**SOUTHEAST LOUISIANA
URBAN FLOOD CONTROL PROJECT
W-14 CANAL IMPROVEMENTS**

SECTION 533(D) REPORT

VOLUME 2

MARCH 2012

Figure 4. Storage Areas and Economic Reaches

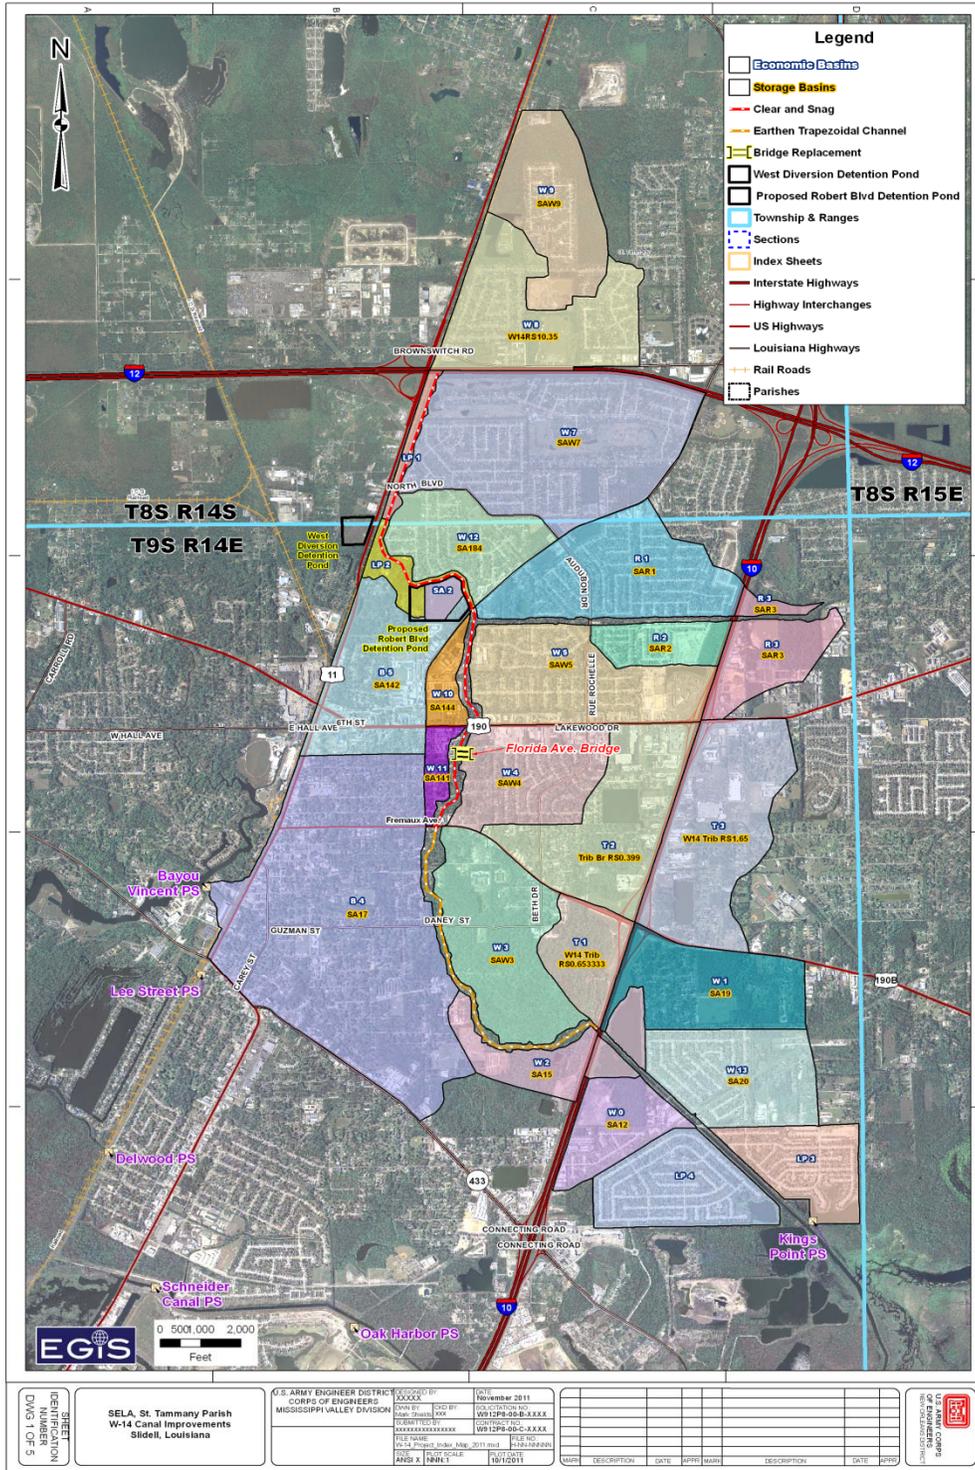
2nd paragraph-2nd line: replace "plus the 15 existing storage areas (10 in Fritchie Marsh) are shown in Figure 2" with "minus the 10 storage areas in Fritchie Marsh are shown in Figure 4"

Add at end of paragraph: "The Economic Reaches are shown in Figure 4 along with the storage areas representing them in the HEC-RAS model"

Figure 6. Reformulated and Existing Condition 10-yr Stages

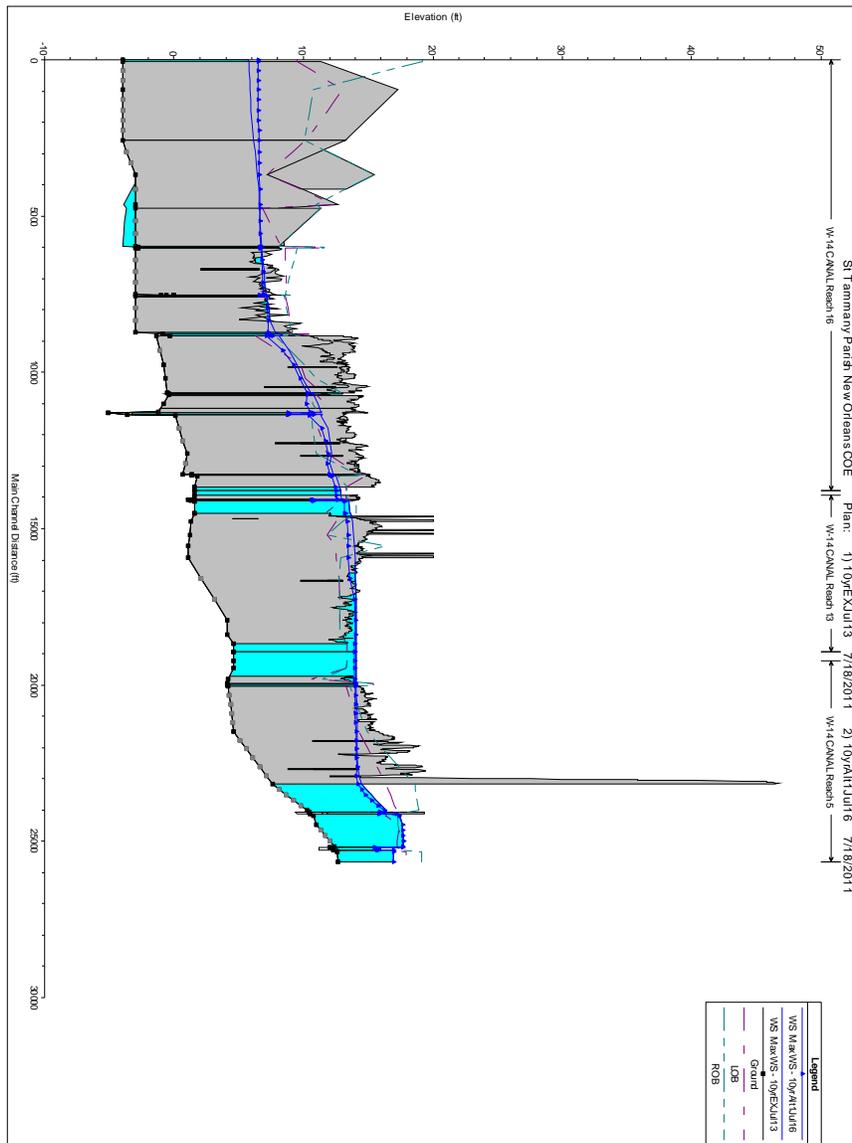
Move Figure 5 to follow paragraph: "Results of the Reformulated Plan Hydraulic Modeling" (change figure number to 6 and figure number 6 to 5)

Change Figure number to 5 in "(see Figure 6). Also change number of picture of Kings Point Pumping Station to 5

1-0 Evaluation Concurred
Revisions completed 1/3/12. Flow lines and legend are visible in Figure 6.
